## City of Mississauga Department Comments

Date Finalized: 2023-03-22 File(s): A31.23

The applicant requests the Committee to approve a minor variance to allow a temporary 5 year change of use proposing to permit a Vehicle Sales/Truck Storage use in an O2 Zone whereas By-law 0225-2007, as amended, does not permit a Vehicle Sales/Truck Storage use in an O2 Zone in this instance.

**Property Address:** 7114 Hurontario St

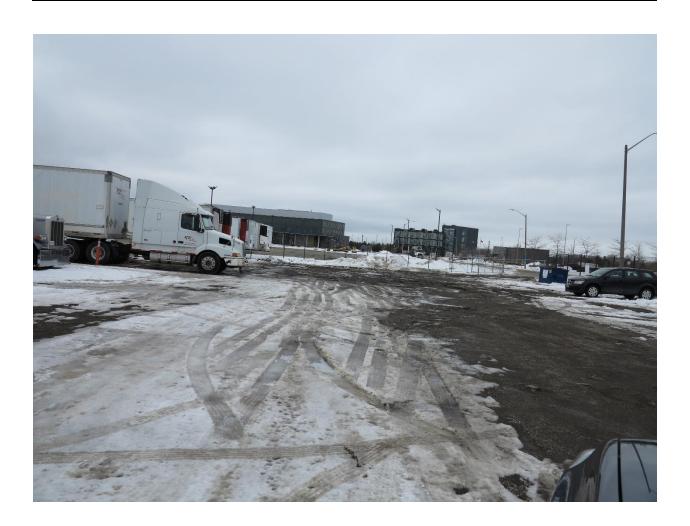
Enclosed for Committees easy reference are a number of photos depicting the subject property. From the enclosed photos it is evident that a significant concern associated with the proposed temporary use would be the mud tracking generated by this use which impacts the municipal roadway.

No information has been provided with regards to any mitigation measures to avoid the mudtracking such as a proposed asphalt area which would typically be constructed at the entrance to the site to help alleviate any mud tracking onto the municipal roadway. Drainage on such a large site also creates some concerns with respect to how it would be self-contained and collected.

Without the above noted concerns being addressed, in particular grading and drainage information it is difficult to adequately evaluate the request. Any impacts on the municipal drainage system (storm sewers) and any mitigation requirements for the quality and quantity impacts of storm water runoff which is generated by the site may also have to be reviewed.
